Don Mills Crossing New Pedestrian & Cycling Bridge Over Rail Corridor

Municipal Class Environmental Assessment - Phases 3 and 4

Public Consultation Summary

August 19, 2021

Figure 1. Switchback Option Encroaching onto Wynford Drive

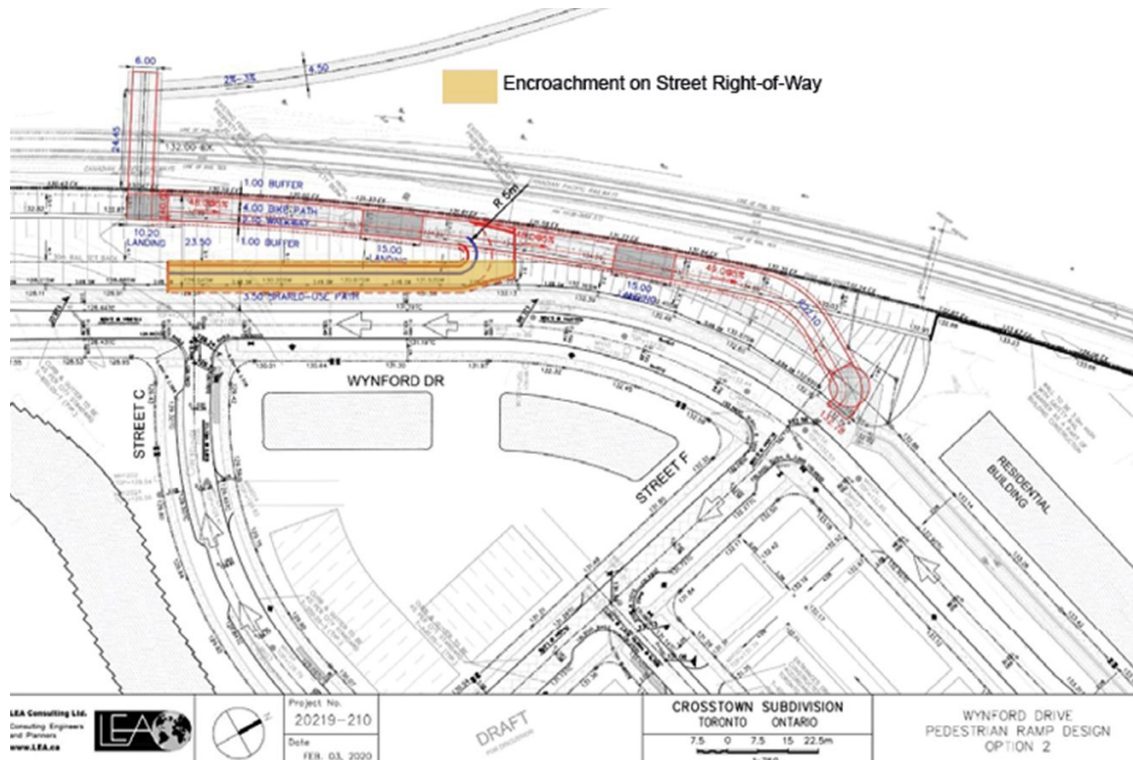
Why the East Side Ramp Goes North, Not South or Switchback

There are a number physical constraints in the immediate area, including the grade of the adjacent Wynford Drive, valley and ravine system, and available land. A switchback ramp design was evaluated and determined to not be feasible as there is insufficient space between the rail corridor and the Wynford Drive extension to accommodate a switchback ramp with a minimum 5-metre turning radius required for cyclists to turn safely (see Figure 1). As illustrated in the drawing below, a switchback design with a 5-metre turning radius will cause the ramp to encroach onto the planned extension of Wynford Drive. Previous [Don Mills Crossing](#) MPS and current Environmental Assessment study also identified that a switchback design at this location would make it difficult for cyclists to maneuver, creating a safety concern for both pedestrians and cyclists.

The current ramp design has been developed to meet the requirements outlined in the Accessibility for Ontarians with Disability Act, while minimizing the amount of backtracking. However, the east ramp must go north due the grade differences on the south side and inability to connect to the proposed street network.
